<b>CLARK • FINEFROCK &amp; SACKETT, INC.</b> ENGINEERS • PLANNERS • SURVEYORS 7135 MINSTREL WAY • COLUMBIA MD 21045 • (410) 381-7500 BALT. • (301) 621-8100 WASH.		
DESIGNED	LOCATION DRAWING 14515 MAC CLINTOCK DRIVE LOT 13 BLOCK "B" SECTION SIX	SCALE 1"=50'
DRAWN	LOTS 1 THRU 6, BLOCK "C" 32 THRU 35, BLOCK "A" 12 THRU 14, BLOCK "B"	DRAWING
CHECKED	WARFIELD ESTATES FOURTH ELECTION DISTRICT HOWARD COUNTY, MARYLAND	JOB NO.
DATE	10-3-02	FILE NO. 02-083-0

## ON-SITE SEWAGE DISPOSAL SYSTEM HOWARD COUNTY HEALTH DEPARTMENT BUREAU OF ENVIRONMENTAL HEALTH

SUBDIVISION: Warfield Estates LOT NUMBER: 13-B

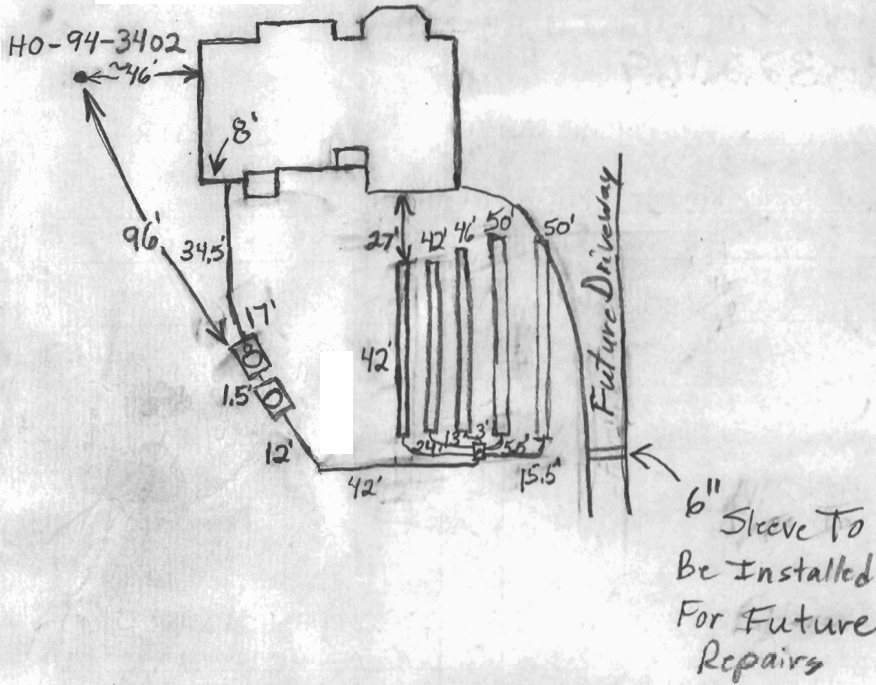
INSTALLATION 2/11/03 Septic tank corner placed about 96' from well - told installer to maintain 100' in future. Trench lengths are approximate, Not present for installation of final 50' trench closest to driveway. Pipe lengths are approximate - not all installed yet. Sleeve to be placed under proposed driveway, measurements to road to be provided by installer. O.K. to cover everything. Need pump and alarm test. (BB) 4/10/03 Pump & Alarm test OK
